## Authors reply and summary of revisions to ‘Topographic controls on landslide mobility: Modeling hurricane-induced landslide runout and debris-flow inundation in Puerto Rico’ based on reviewer comments

by Dianne L. Brien, Mark E. Reid, Collin Cronkite-Ratcliff, and Jonathan P. Perkins

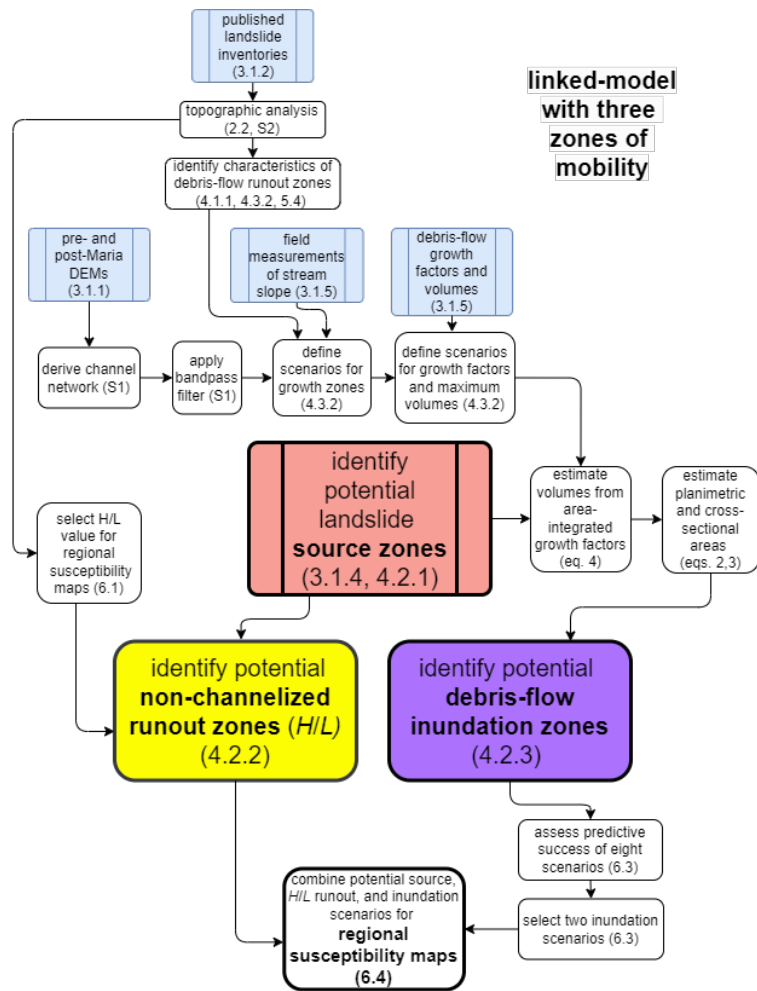
*It was very difficult to understand the overall structure of the proposed model. I think that Figure 5 fulfills that role, but it difficult to understand. I made a few comments about this figure in comment 2.*

*Also, I think it is easier to understand if the relationships among the three models are the same in Figures 2 and 5. Also, it would be easier to understand if it indicated where in the text the methods for each part of the figure are written.*

*Also, a list of the conditions and coefficients that need to be determined for the terrain classification and each model is helpful to understand overall structure of the proposed model, Moreover. it would be easier for readers to understand if the determination method in this research was organized in the list. It would be very informative for future research if the authors could clarify which of the conditions that need to be determined have the greatest impact.*

Thank you for these comments. Reviewer 2 also indicates that figure 2 did not serve the intended purpose. Figure 2 was intended as a primer, showing a simplified version of the linked model approach, without the details provided in figure 5. The three colored boxes in figure 2 and figure 5 (figure 4 in revised version) are equivalent and highlight the main components of the linked model. The use of slightly different wording in the two figures may have made this connection difficult to see. We have eliminated figure 2.

Figure 5 has been significantly revised and now includes the associated section numbers. The flowchart details describing the topographic analysis have been moved to a supplement. The revised figure 5 now shows the connection to the topographic analysis as a more simplified, minor component, providing a primary emphasis on the linked model. The main components of the linked model are now further highlighted with larger boxes and font size. Here is the revised figure 5 flowchart :
